LEGAL DESCRIPTION
TRACT Q-7-A-1, ATRISCO BUSINESS PARK, UNIT 4, CITY OF ALBUQUERQUE, BERNALILLO COUNTY, NEW MEXICO.

CHECKER AUTO - COORS BLVD.
GRADING AND DRAINAGE PLAN

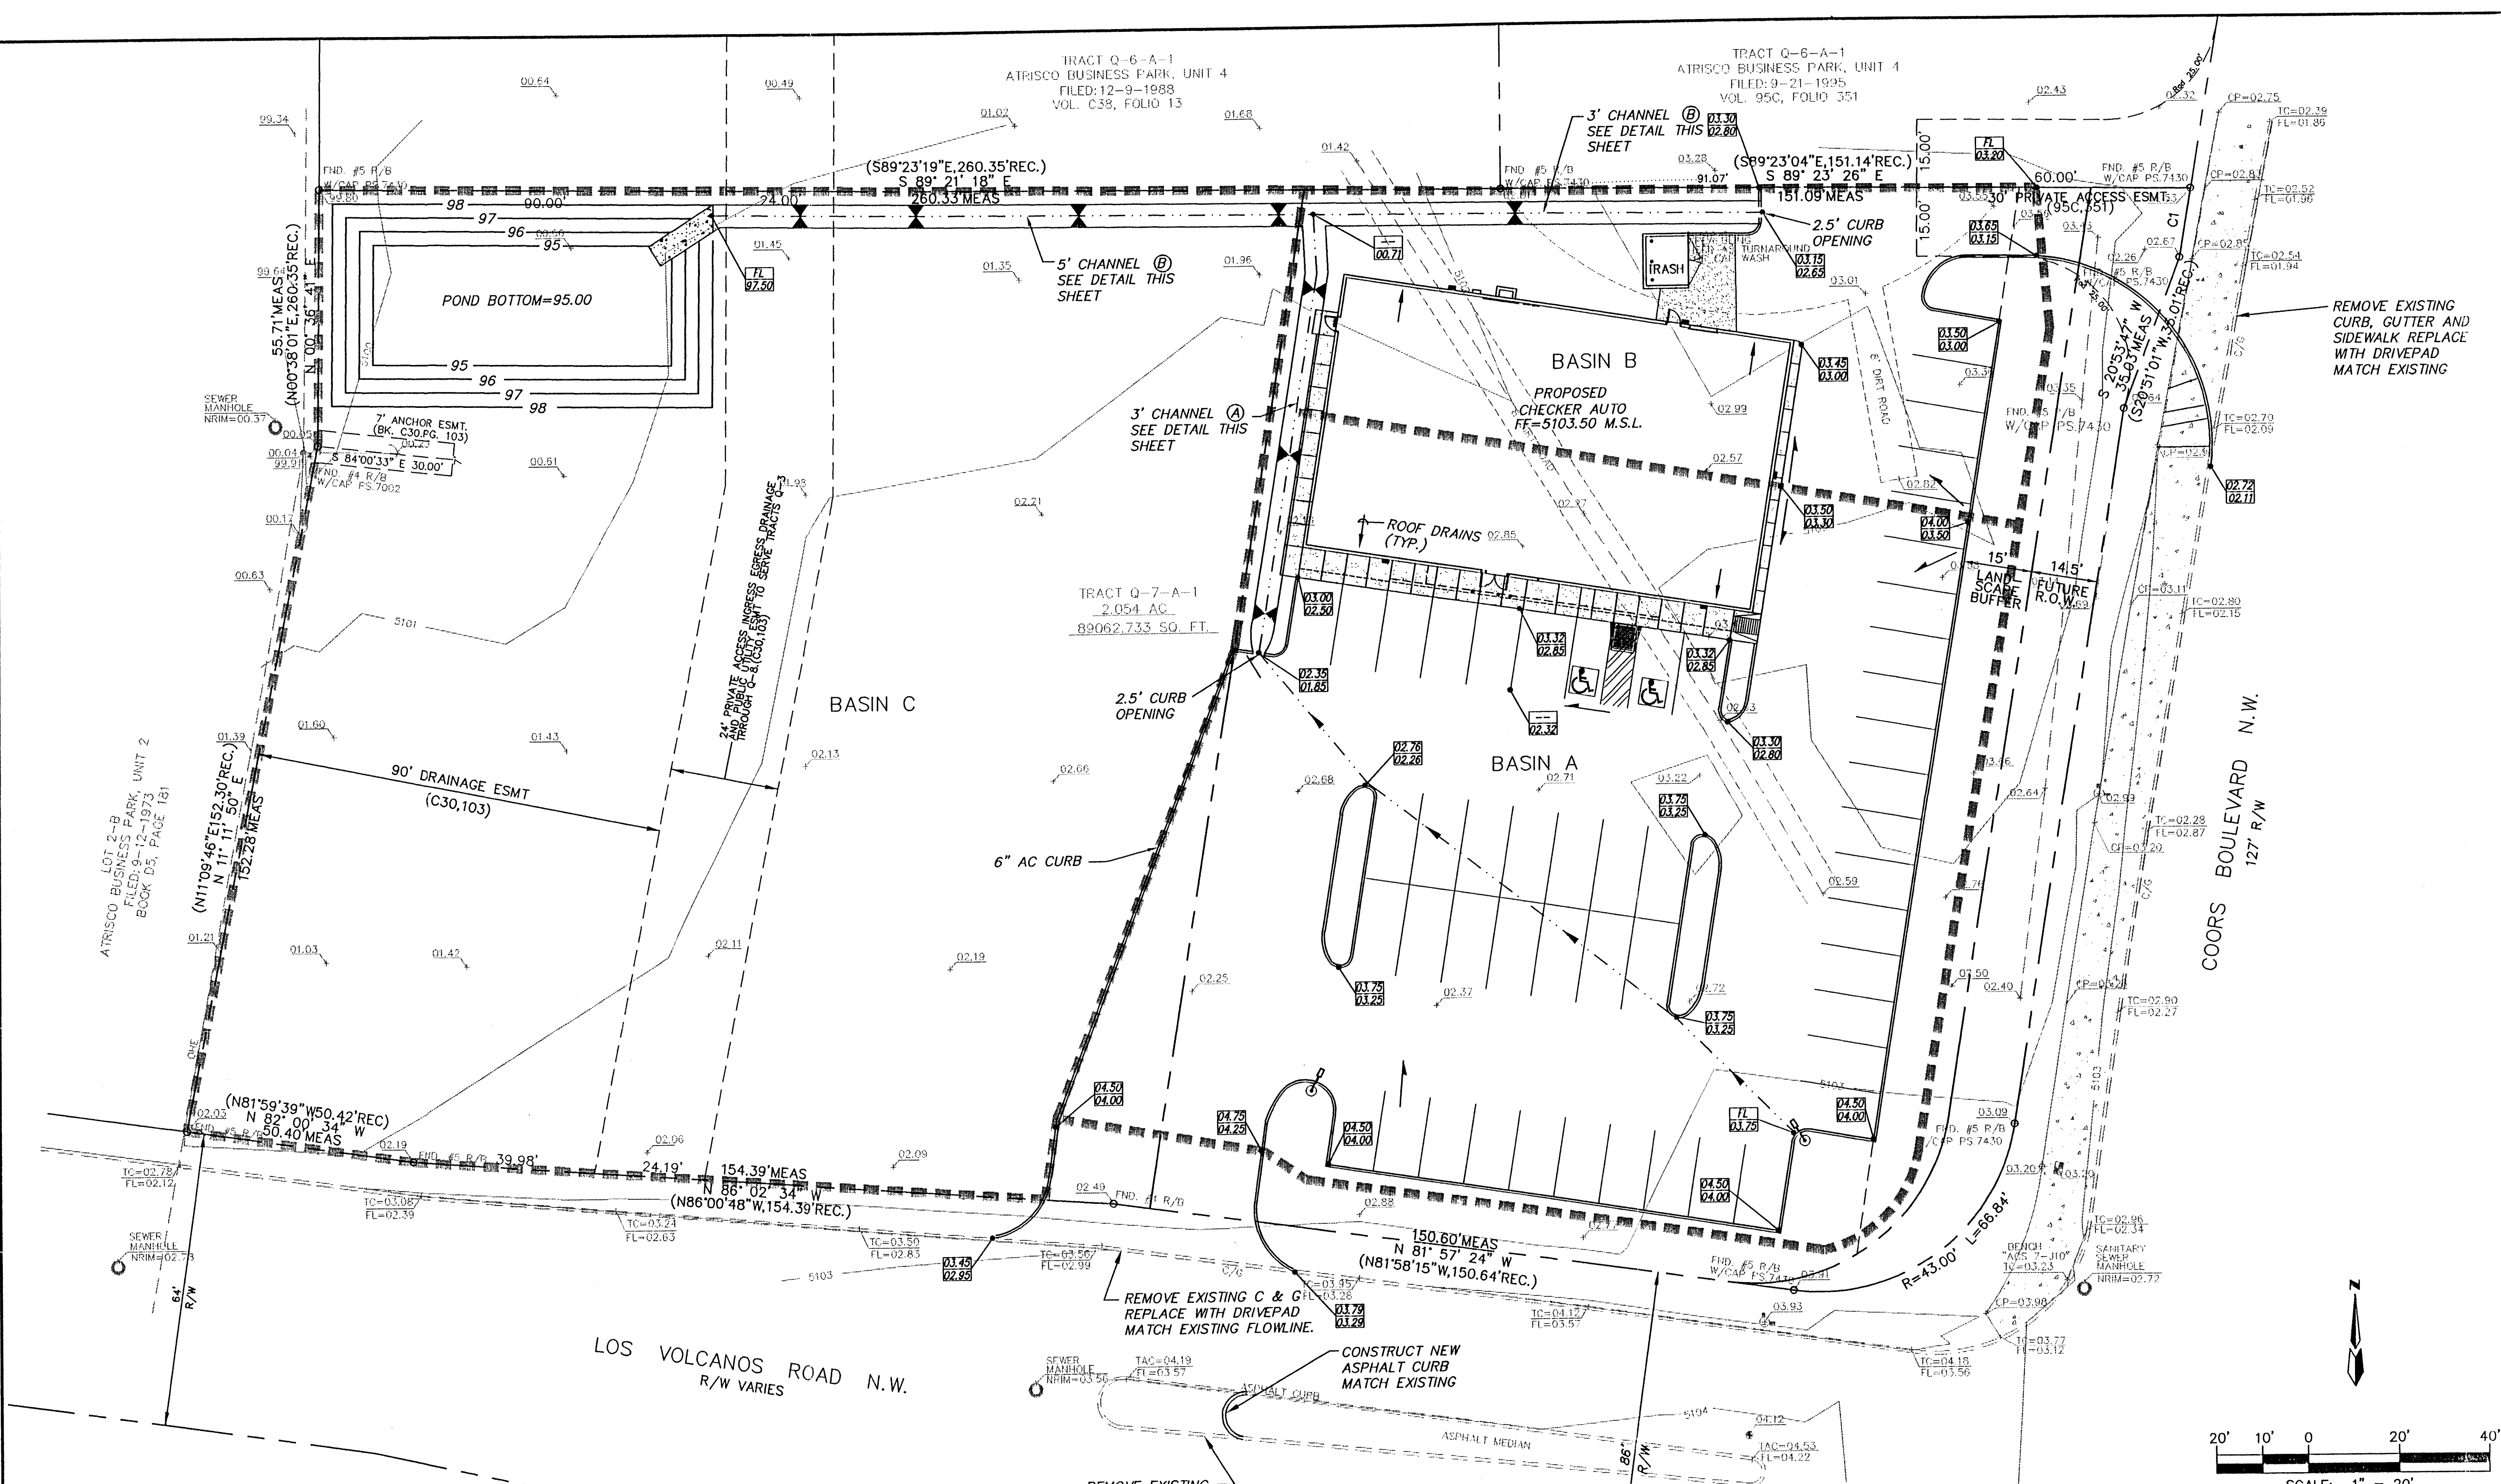
*1. How will the interior condition be eliminated when the right-of-way system is completed?
2. You need to indicate the final concept.
3. Will you be in with central drainage?*
